Office Action Summary	Application No. 10/582,035	Applicant(s) SHEN ET AL.	
	Examiner ROBERT HUBER	Art Unit 2892

DETAILED ACTION

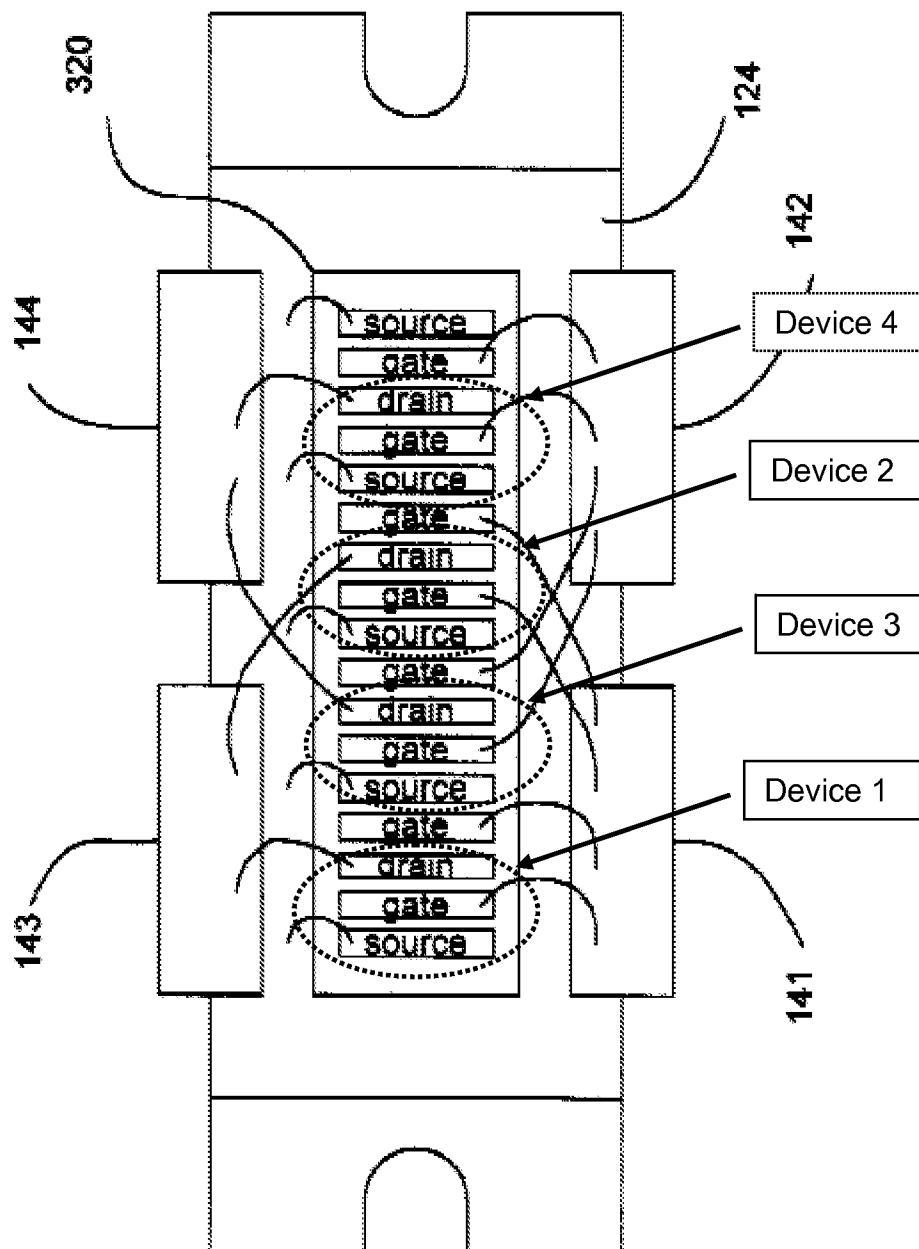
a. Regarding claim 1, **Perugupalli discloses a monolithic structure** (e.g. figure 11, and clarified in the figure below), **comprising:**

a first pair of devices (devices 1 and 2, as seen in the figure below) **and**
a second pair of devices (devices 3 and 4, as seen in the figure below), **each**
pair of devices comprising:

a first lateral device having a first source terminal, a first drain
terminal, and a first gate terminal (e.g. first lateral devices 1 and 3 each have a source, drain, and gate terminal, and are lateral, as seen in the figure below and

wherein (i) in each pair of devices, said first drain terminal is connected to said second drain terminal (e.g. as seen in the figure below, first drain terminal of device 1 is connected to second drain terminal of device 2 via the drain lead 143, and first drain terminal of device 3 is connected to second drain terminal of device 2 via the drain lead 144), **and said first gate terminal is connected to second to said second gate terminal** (e.g. first gate terminal of device 1 is connected to second gate terminal of device 2 via gate lead 141, and first gate terminal of device 3 is connected to second gate terminal of device 4 via gate lead 142),

(ii) in each pair of devices, each first lateral device is combined with each second lateral device on said substrate (e.g. as seen in figure 11), **(ii) both first source terminals are connected to both second source terminals to define a common source terminal of the monolithic structure** (e.g. as seen in the figure, both first source terminals are connected to both second source terminals via common source terminal 124), **and**

(iv) a first electrically isolated lead comprises the common source terminal (source terminals are connect to each other via wire bonding to the isolated lead 124, as seen in figure 11 and disclosed in col. 5, lines 14 – 19).

independent of the first and second drain terminals of the second pair of devices (e.g. as seen in the figure above, first and second drain terminals of the first pair of devices, 1 and 2, are connected to drain lead 143, while first and second drain terminals of the second pair of devices, 3 and 4, are connected to drain lead 144. Therefore, they are independent).

c. Regarding claim 4, **Perugupalli in view of Mehta disclose the monolithic structure of claim 3, as cited above, wherein said first and second gate terminals of the first pair of devices are electrically independent of the first and second gate terminals of the second pair of devices** (e.g. as seen in the figure above, first and second gate terminals of the first pair of devices, 1 and 2, are connected to gate lead 141, while first and second gate terminals of the second pair of devices, 3 and 4, are connected to gate lead 142. Therefore, they are independent).
